December 27, 1994

Docket Nos. 50-424  
50-425

**VOGTLE ELECTRIC GENERATING PLANT  
REQUEST TO REVISE TECHNICAL SPECIFICATIONS  
REVISION TO LEAK TEST FREQUENCY FOR VALVES WITH RESILIENT SEALS**

**FIGURE 1-1**

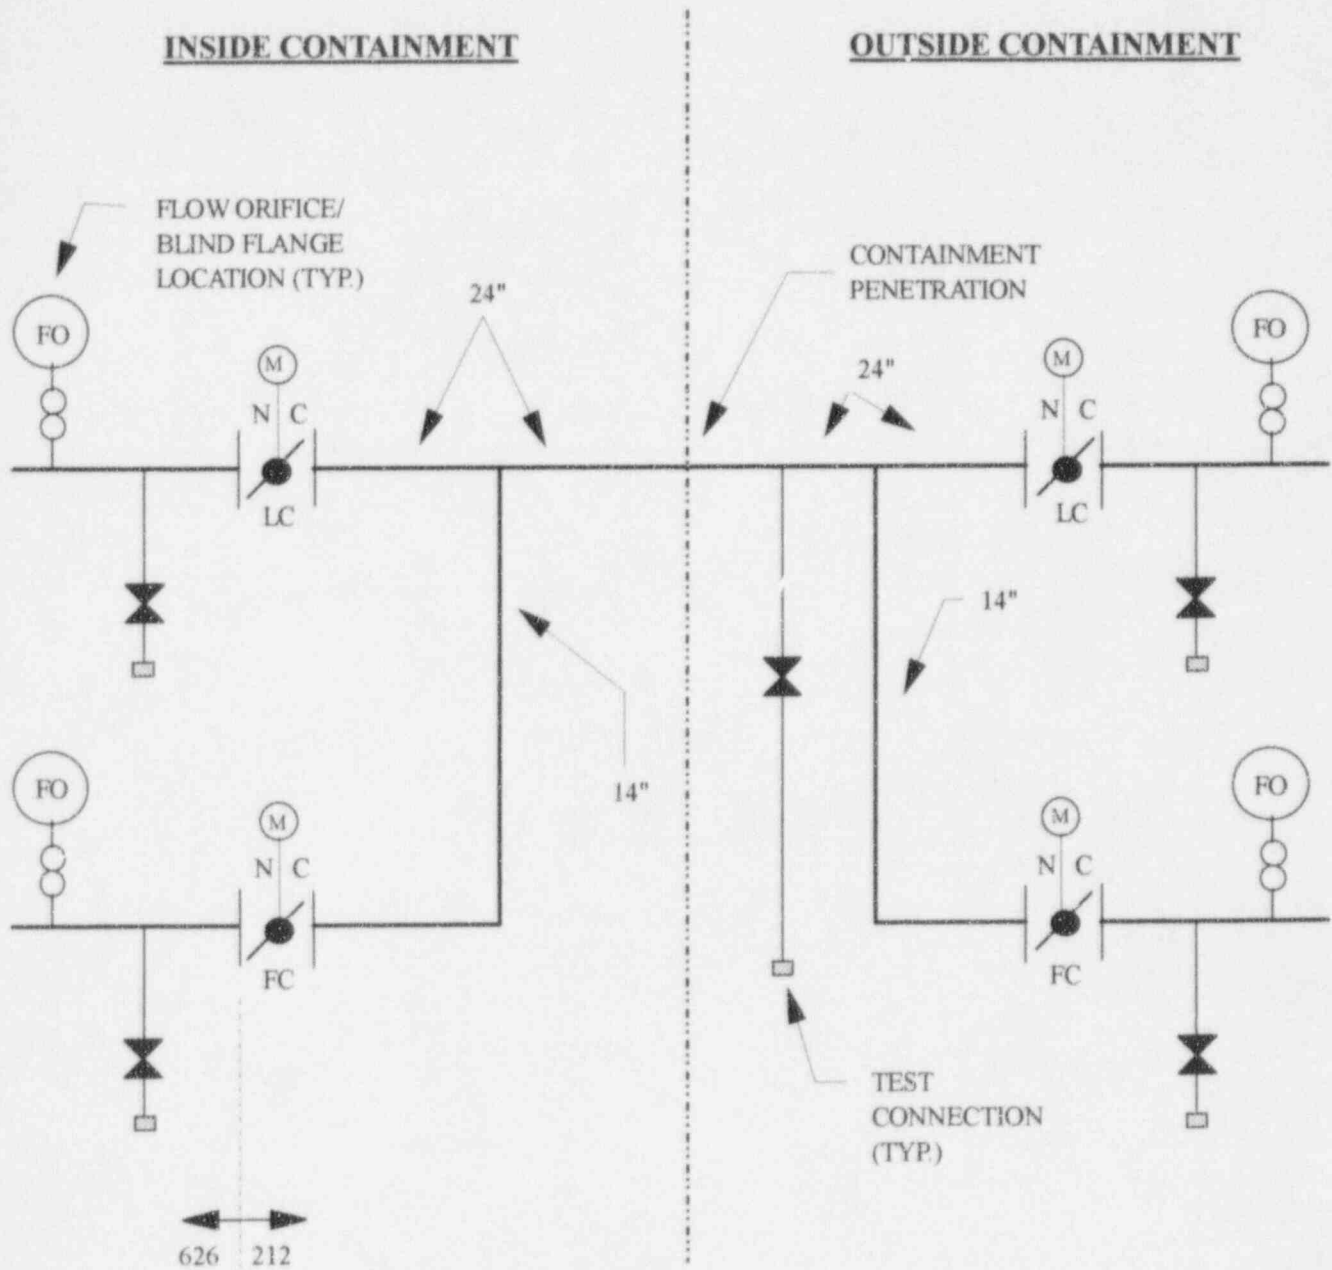
The proposed change to the Technical Specifications (TS) will change specification 4.6.1.7.2 from "At least once per 3 months the containment purge valves with resilient material seals in each sealed closed containment purge supply and exhaust penetration shall be demonstrated operable..." to "At least during each refueling outage the containment purge valves with resilient material seals in each sealed closed containment purge supply and exhaust penetration shall be demonstrated operable...", and delete the phrase "...will provide early indication of resilient material seal degradation and..." from bases section 3/4.6.1.7.

During the initial licensing of the Vogtle Electric Generating Plant the NRC staff expressed concerns about seal degradation for large isolation valves having resilient seats. In response to this concern Georgia Power Company and the staff agreed to a program of accelerated testing for these valves. Georgia Power believes that the concern was based on the lack of confidence in the performance of resilient seats and that the intent of the accelerated testing program was to determine if increased testing was needed on a permanent basis. Georgia Power Company has conducted quarterly tests on these valves since 1987 and has determined that seal degradation does not occur. Based on the results of these tests we have concluded that increased testing is not required on a permanent basis and that the history of these valves supports a test interval in accordance with 10 CFR 50 Appendix J. The results of the tests are tabulated in table 1-1 which demonstrates that the measured leak rates have consistently been well below the allowable leakrate (26,320 SCCM) and that there were no instances of increased leakage due to degradation of resilient seats. Figure 1-1 provides a schematic of the valve arrangement and identifies the valves referenced in table 1-1. The conclusions about the performance of the resilient seat material and the revision to the testing frequency is consistent with the findings of the NRC staff on other operating plants. (See SER for Amendment 54 to operating license DPR-18, TAC number M77849) Since the leak test requires the construction of scaffolding and installation of flanges, the change to the frequency will significantly reduce the level of required activity inside containment during plant operation by allowing the tests to be conducted during refueling outages.
